ADDENDUM NO. 5

RE: Item #1, February 19, 2025 Letting - IM-B-CR 2292(101)3, PCN 05HN, Minnehaha County - Grading, PCC Surfacing, Structures (10x4 RCBC extension, 163' Temporary Bridge, (2) 400' Steel Girder, (2) 12x8 CIP RCBC), Retaining Walls, Curb & Gutter, Storm Sewer, Signals, Lighting

STATE OF SOUTH DAKOTA	PROJECT IM-B-CR 2292(101)3	SHEET B28	TOTAL SHEETS B225
Plotting Date: 2/18/2025		Revised Date: 2/18/2025 Initials: NBG

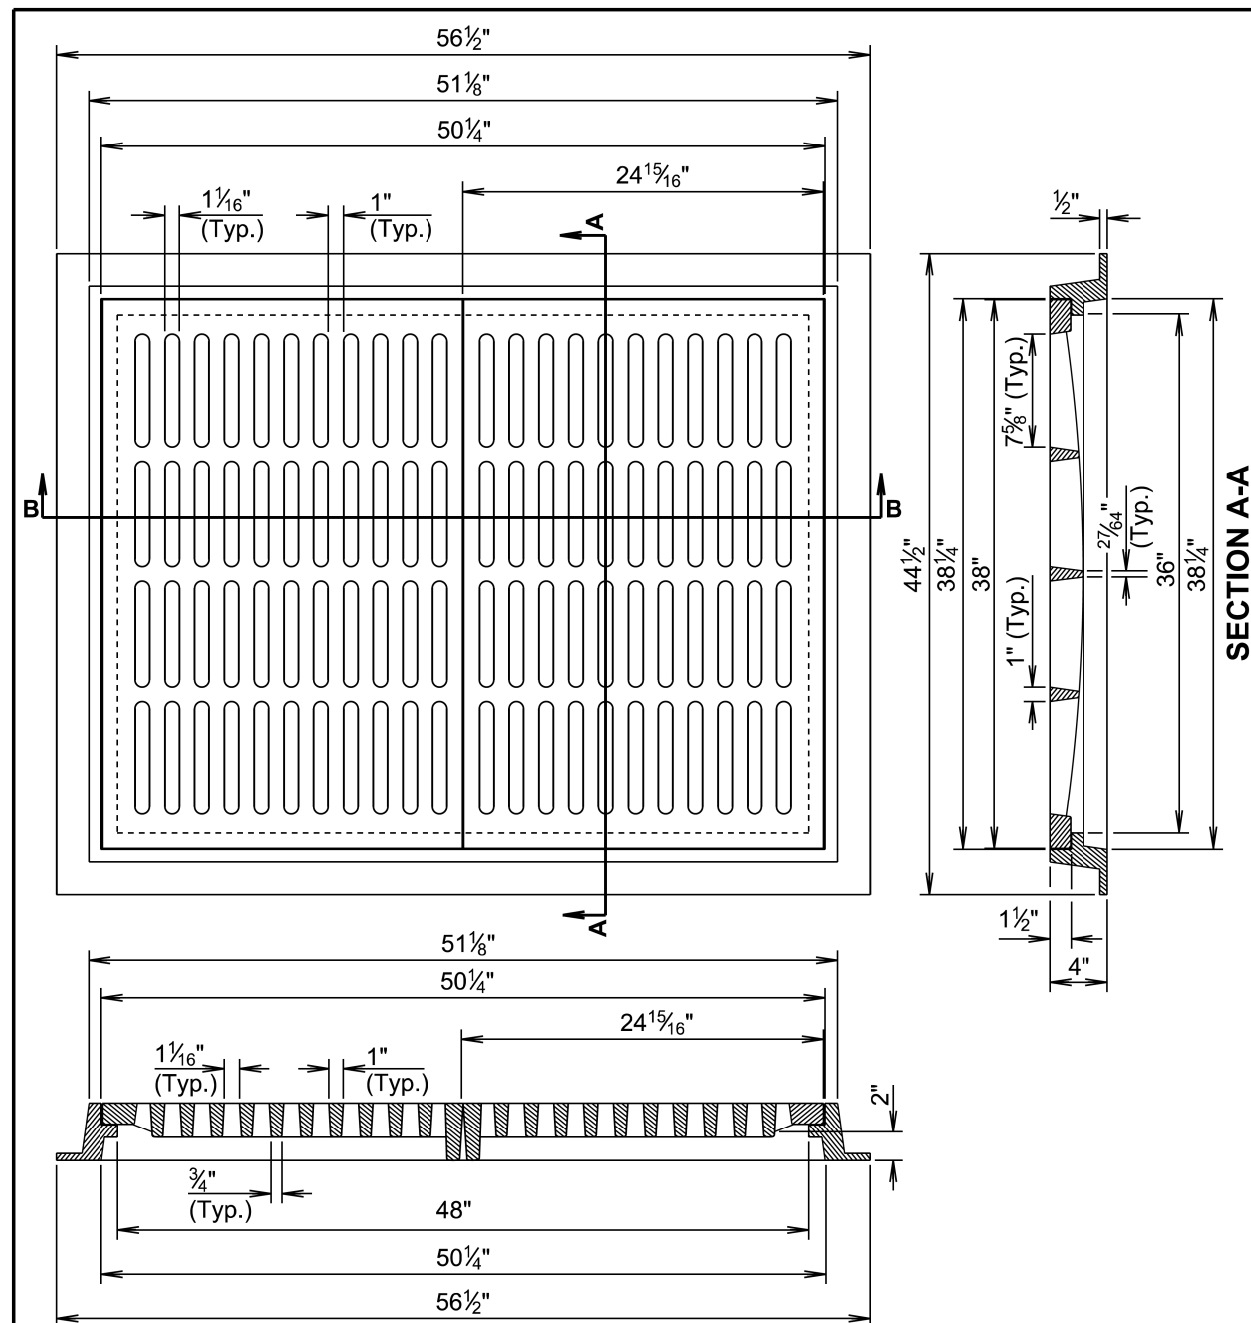
Sheets B26, B27 & B28: TABLE OF STORM SEWER DROP INLETS AND QUANTITIES was revised.
Informational notes were revised.

Published Date: 2025	SDDOT	TYPE C FRAME AND GRATE	PLATE NUMBER 670.82
			Sheet 1 of 1

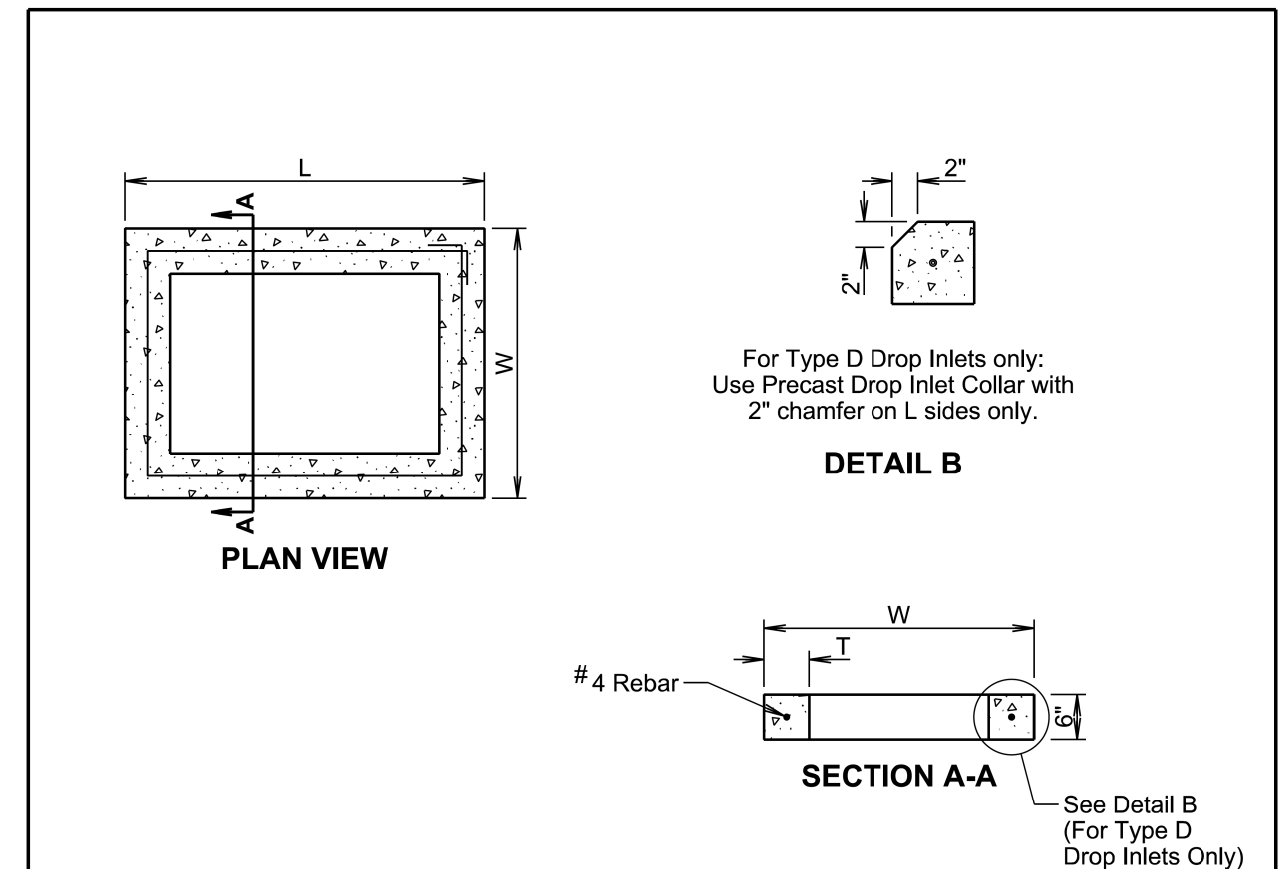
Sheet B212: Standard Plate 670.82 was added.

STATE OF SOUTH DAKOTA	PROJECT IM-B-CR 2292(101)3	SHEET L27	TOTAL SHEETS L73
-----------------------	-------------------------------	--------------	---------------------

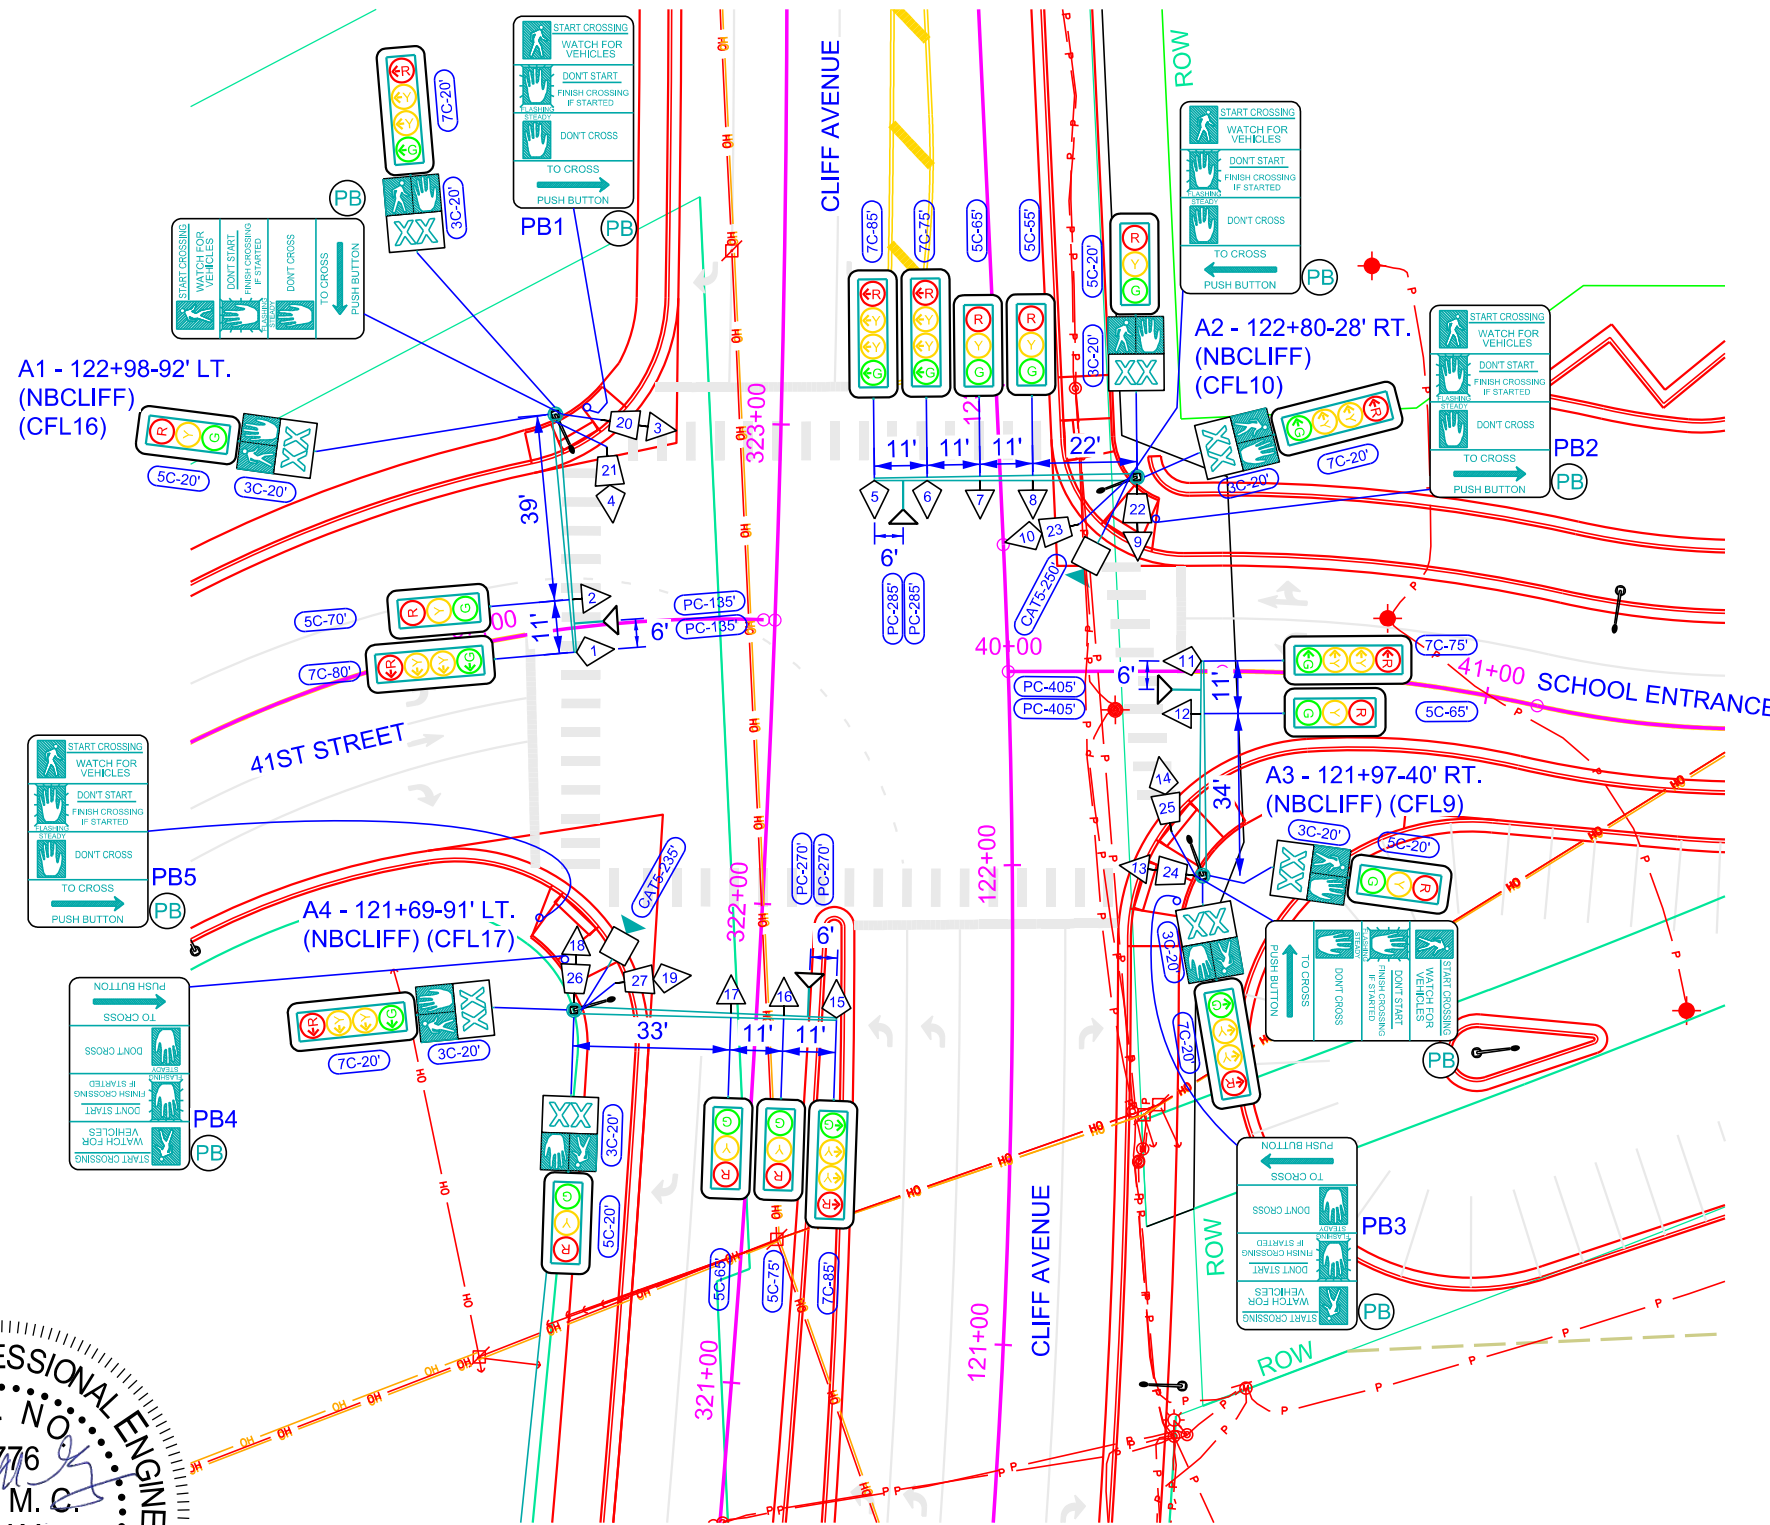
Sheet L27 & L32: ESTIMATE OF QUANTITIES was revised.

ESTIMATE OF QUANTITIES			
KEY	ITEM	UNIT	EST QUANT
	Signal Pole w/45' Mast Arm & 8' Lumin Arm, 40' Mt Ht (A3)	EACH	1
	Signal Pole w/50' Mast Arm & 8' Lumin Arm, 40' Mt Ht (A1)	EACH	1
	Signal Pole w/55' Mast Arm & 8' Lumin Arm, 40' Mt Ht (A2, A4)	EACH	2
	3 Section Vehicle Signal Head (2,3,7,8,9,12,13,16,17,18)	EACH	10
	4 Section Vehicle Signal Head (1,4,5,6,10,11,14,15,19)	EACH	9
	Optical Detector	EACH	4
	Accessible Pedestrian Signal Push Button	EACH	8
	Pedestrian Signal Head w/Countdown Timer (20,21,22,23,24,25,26,27)	EACH	8
	Adaptive Signal Camera and Equipment (1 Processor)	EACH	2
	Pedestrian Push Button Pole (PB1,PB2,PB3,PB4,PB5)	EACH	5
	Pedestrian Crossing Sign R10-3b (Left - 4/Right - 4)	EACH	8
	Emergency Vehicle Preemption Unit	EACH	1
	3' Diameter Footing (A1,A2,A3,A4)	FT	46.0
